GROUP	MODEL
Emissions Service	2020MY
Campaign	Sportage (QL)
	w/2.0L T-GDI
NUMBER	DATE
SC222 (Rev 1, 06/16/2022)	April 2022

VOLUNTARY EMISSIONS SERVICE CAMPAIGN

VEHICLE EMISSION CONTROL INFORMATION (VECI) LABEL REPLACEMENT (SC222)

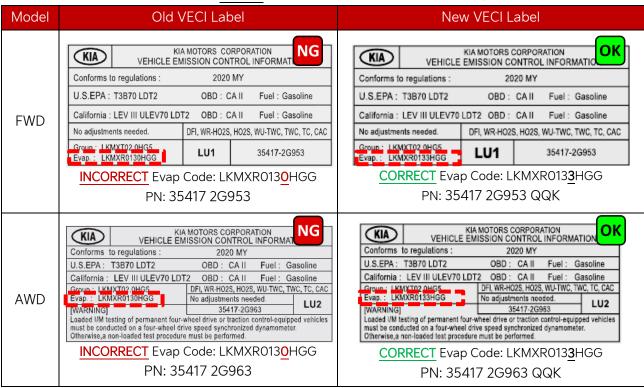
This bulletin provides information to replace the Vehicle Emission Control Information (VECI) label on some 2020MY Sportage (QL) vehicles with 2.0L T-GDI engines produced from December 19, 2018 through May 13, 2020. An incorrect VECI label was installed during production of these vehicles. The VECI label is extremely important when performing maintenance, emissions inspection, or ordering engine and engine management related parts. It also contains the code that tells a testing facility which test to perform to ensure the vehicle is tested to the correct emission standard. The U.S. Environmental Protection Agency and California Air Resources Board consider the under hood VECI label an integral part of state emission testing. If the VECI label is incorrect, the vehicle may fail the emission testing, even if it meets applicable emissions standards. Follow the procedure outlined in this publication to affix the correct VECI label. Before conducting the procedure, verify that the vehicle is included in the list of affected VINs.

2. Select the new VECI label with the **correct** EVAP information for FWD or AWD, as shown below.

4. Carefully affix the new provided VECI label over the old VECI label, ensuring complete coverage of the old label with the new one.

Ensure the correct label (FWD or AWD) is affixed to the vehicle. Refer to Parts Information for proper part number.
